Access Compliance Report

Public Rights-of-Way

Intersection ID: 45550	Main Street: PEACHTREE_RD	Cross Street: ROOK_RD	Location:	E
ADA ID: C249696DA035	Ramp Type: PerpDiag	Initial Pass/Fail: Fail	Overall Compliance: No	Severity Score: 10

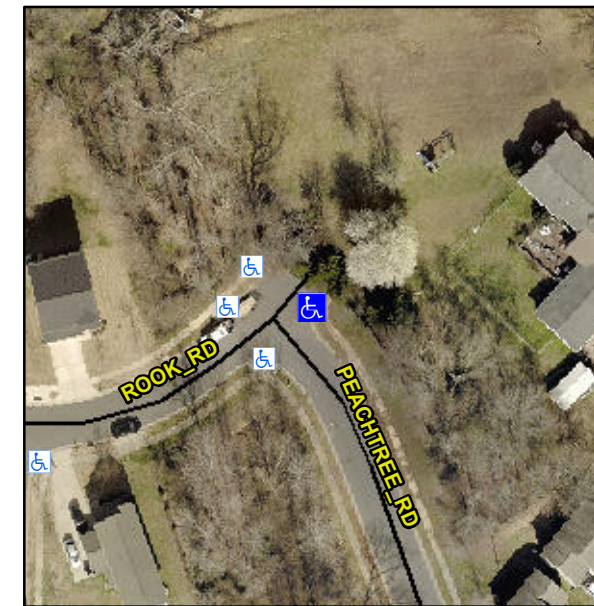
Not Found, R304.5.1, R304.5.3

Compliance	Description	Data	Compliance	Description	Data
N/A	Ramp Length (in)	84.0	Yes	Ramp Slope (%)	5.0
No	Ramp Width (in)	38.0	No	Ramp XSlope (%)	2.2
N/A	Flare Type LT	N/A	N/A	Flare Type RT	N/A
N/A	Flare Slope LT (%)	N/A	N/A	Flare Slope RT (%)	N/A
N/A	Flare Traversable LT?	N/A	N/A	Flare Traversable RT?	N/A
N/A	Landing Length (in)	N/A	N/A	DWS Provided?	N/A
N/A	Landing Width (in)	N/A	N/A	DWS Contrast?	N/A
N/A	Landing Slope (%)	N/A	N/A	DWS Length (in)	N/A
N/A	Landing X Slope (%)	N/A	N/A	DWS Full Width?	N/A
N/A	Landing Curb? (Y/N)	N/A	N/A	DWS Offset (in)	N/A
N/A	Shared Landing?	N/A			
N/A	Gutter Ponding?	N/A	N/A	Gutter Slope (%)	N/A
N/A	Gutter Lip Ht (in)	N/A	N/A	Gutter X Slope (%)	N/A
N/A	Painted X Walk1?	No	N/A	Painted X Walk2?	No
	X Walk 1 Direction	To N		X Walk 2 Direction	To SW
N/A	X Walk 1 Width (in)	N/A	N/A	X Walk 2 Width (in)	N/A
	X Walk 1 Slope (%)	1.9		X Walk 2 Slope (%)	0.2
	X Walk 1 X Slope (%)	1.6		X Walk 2 X Slope (%)	0.5

Remove & Replace Curb Ramp With Two New Directional Ramps or Equivalent.
